MEMORANDUM

TO: Board of Adjustment
FROM: Daniel Word, Planner Principal, Residential Review
DATE: December 31, 2014
SUBJECT: Appeal of Building Permit Approval at 904 Jessie Street

904 JESSIE STREET (PERMIT NUMBER 2014-102999 PR)

A1.1

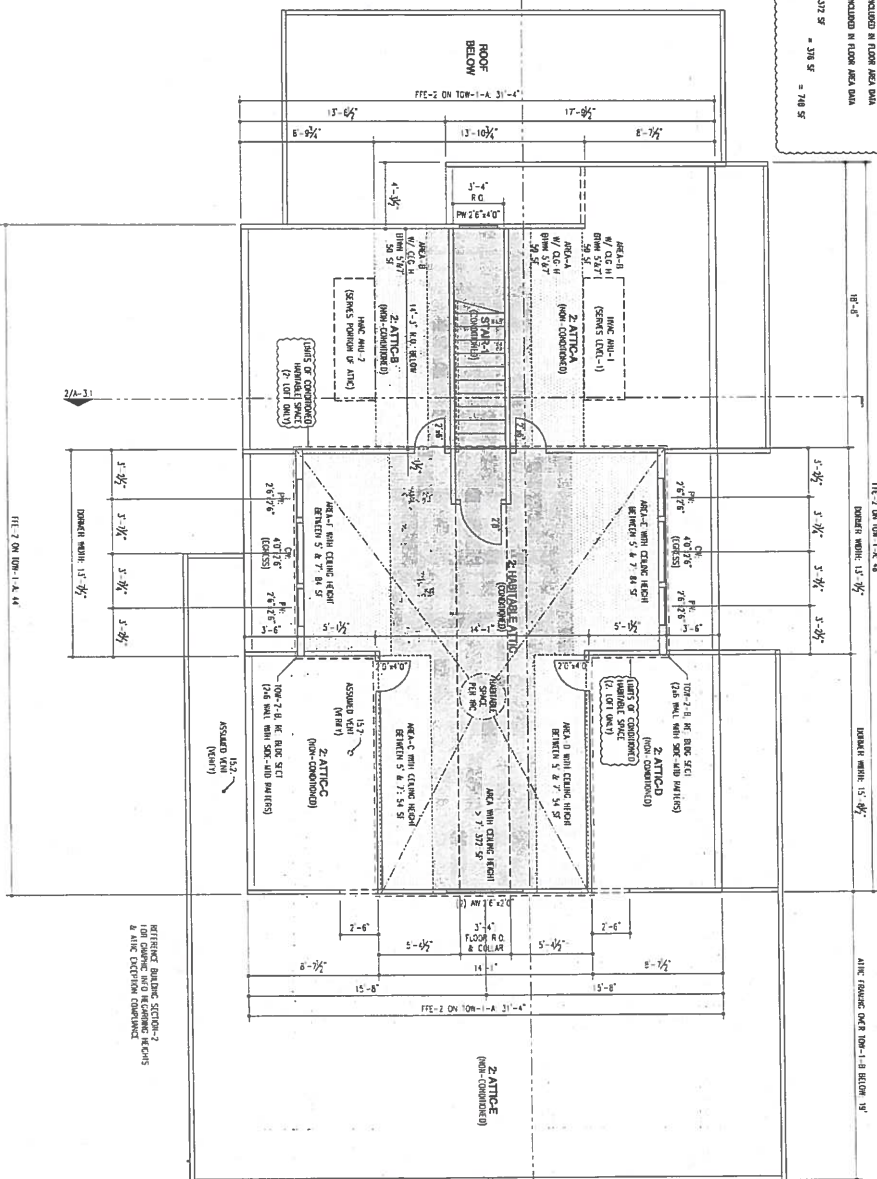
The architectural plans of the first and second floor appear to be drawn to the outer edge of the wood framing and not to the "outside surface of the exterior walls" which is demonstrated by the fact that the first floor plan dimensions match the foundation plan dimensions. Normally, the edge of the framing is aligned with the foundation edge. When sheathing and siding are added, this dimension is typically increased by more than an inch on all sides. Since the criteria for calculating the McMansion FAR is measurement to the "outside surface of the exterior walls", the McMansion FAR is not calculated correctly. If one assumes a ½" sheathing and ¾" siding, the first floor area is increased 22.9 sq ft and the basement floor area is increased by 10.3 sq ft. This is an additional 33.2 sq ft that must be added to the McMansion FAR calculation. Using AutoCAD and the applicant's dimensions, ZNA calculated an area of 1,893.0 sq ft for the first floor and 968.9 sq ft for the basement floor as measured to the edge of framing, for a total of 2,861.9 sq ft. Adding the additional 33.2 sq ft for the area from the edge of framing to the outside surface of the exterior wall makes the total FAR 2,895.1 sq ft. This is 40.17% or 12.7 sq ft over the maximum limit of 40%. The gross floor area contained in the floor plans must be reduced to comply with the LDC.

- a) The applicant is utilizing an L-shaped carport, which creates issues in calculating the percentage of the opening on the north side of the carport. ZNA believes utilizing an L-shaped carport allows one to misinterpret the intent of the ordinance and circumvent it. There is no real question as to the length of the opening. However, there is a difference of interpretation with respect to the overall length of the wall to be used in calculating the percentage of the opening. There are three ways one might calculate the overall length of the north wall as shown in Exhibit A. The applicant is utilizing Method 2 although some applicants are even arguing for the use of Method 3. ZNA believes Method 1 is the correct way to calculate the opening. Using this method, the opening is only 59.3%. Using Method 2, the opening is almost exactly 80%. Please note that in using Method 2, the applicant calculates the opening percentage to be 81.3% as shown in Drawing A3.1. This is because the applicant incorrectly uses an overall length of 18'-8½" instead of the actual 19' as shown on the first floor plan in Drawing A1.1.

Regarding the first issue, staff concurs with the position of the appellant that gross floor area measurements should be taken to the “outside surface of the exterior walls” as written in the code, which in the opinion of staff, should include exterior finishes, inclusive of masonry, siding, stucco or other materials. Staff respectfully requests the Board uphold the appeal and require the construction plans be corrected to comply with the interpretation of both staff and the appellant as it relates to the calculation of gross floor area.

Regarding the second issue, as a control to the potential absurdities created by the limited language in the code, staff suggests using the minimum stall width and depth requirements as a guide in determining a “side” of a carport. For instance, if an applicant is proposing a two-car carport, with parking stalls adjacent (side-by-side) to one another, such as is the case presented tonight, that no “side” used toward the minimum opening requirement be less than 17 feet in length.

Method 1

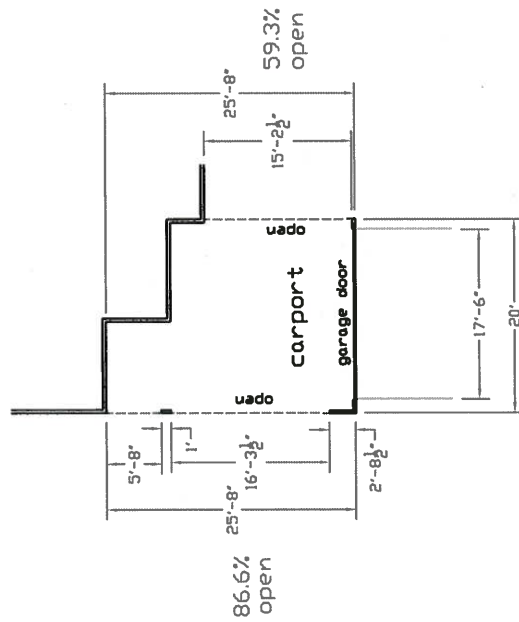
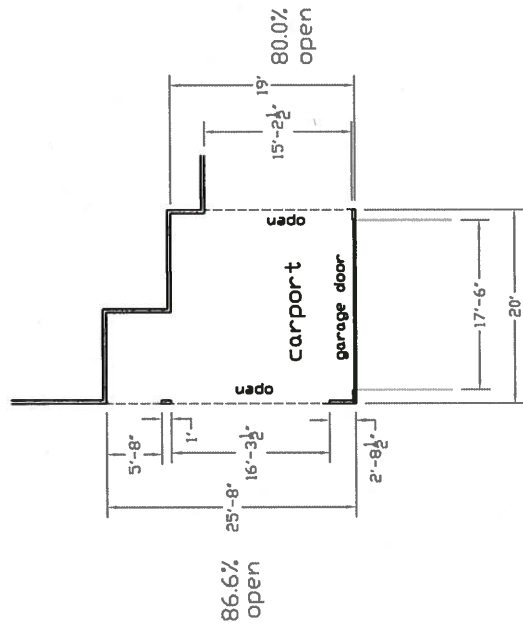
ZNA believes it is a misinterpretation of the ordinance to not require the overall measurement along the full length of the entire carport. The problem associated with using Method 2 is illustrated more fully in Examples 1 through 6 of Exhibit B. As part of

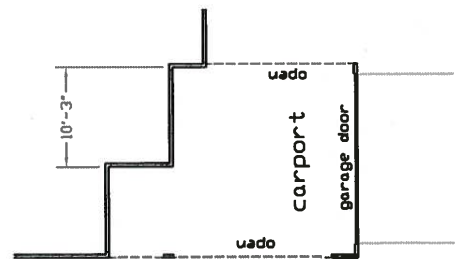
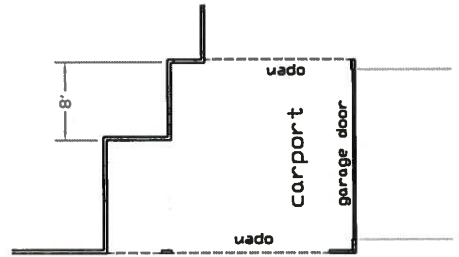
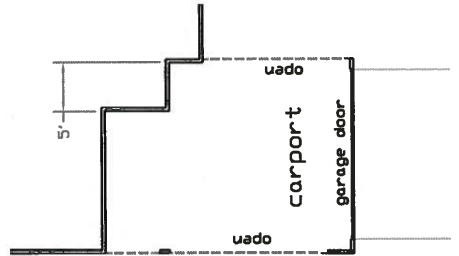
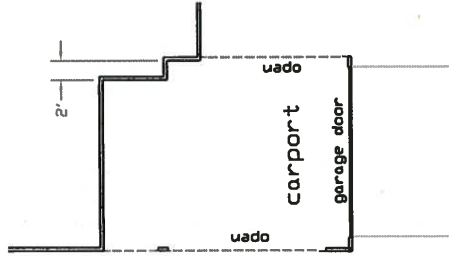
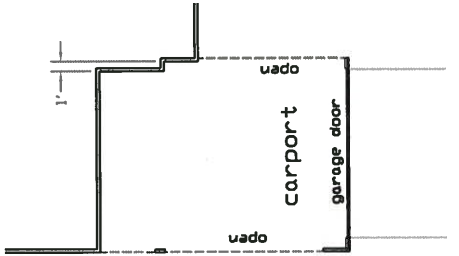
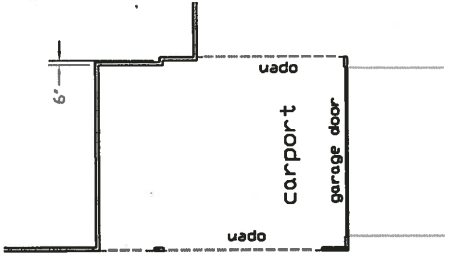
the internal carport wall shifts from Example 1 to Example 6, it becomes more and more apparent that the overall length of the wall opening should be measured using Method 1. If one were to accept the use of Method 2, then it must be decided at which point (from Example 1 to Example 6) the measurement of the overall length should be switched to Method 1 from Method 2.

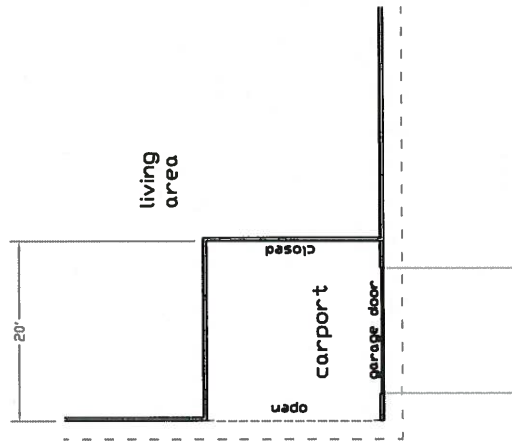
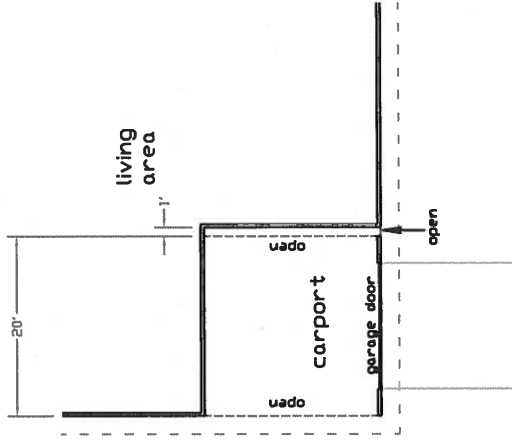
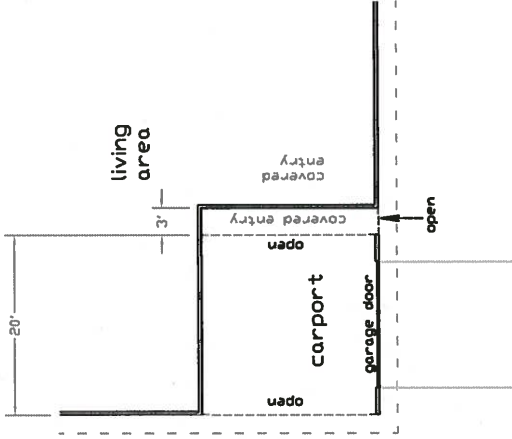
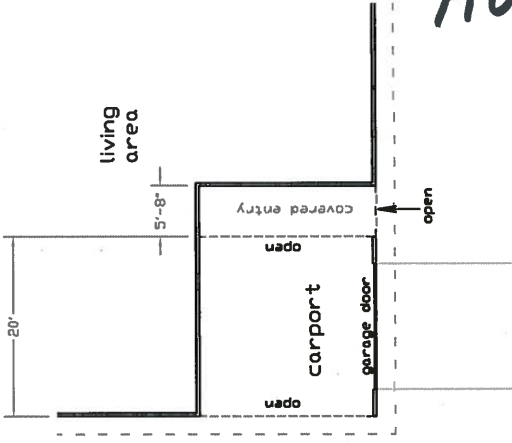
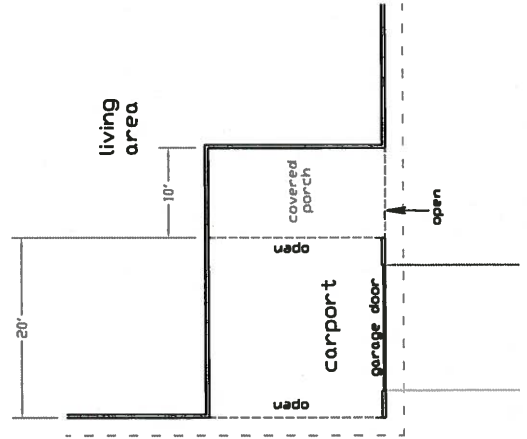
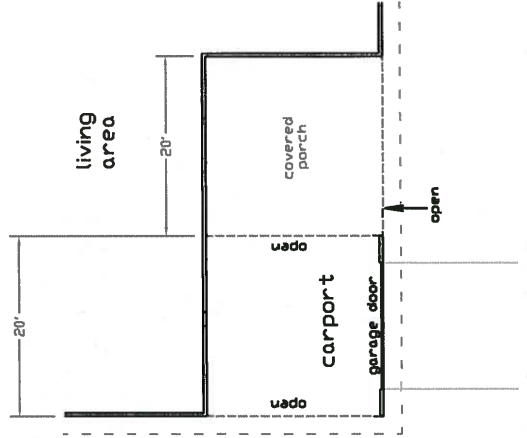
Exhibit B illustrates possible examples of parking areas that are adjacent to covered and enclosed entry ways. ZNA believes that Examples 1 through 6 are instances where the carport opening is not clear and unobstructed. We believe Examples 7 and 8 are acceptable under the current wording of the ordinance.

The code does not openly prohibit porches from being located adjacent to carport areas provided that the porch cannot reasonably be used as additional parking space. This fact, coupled with the finding that the covered porch adjacent to the carport area meets the minimum dimensions for egress, landings, and hallways, staff suggests the porch area be analyzed independently of the carport area. Thus staff recommends that the Board deny the appeal and support the staff interpretation as it relates to the “carport exemption”.
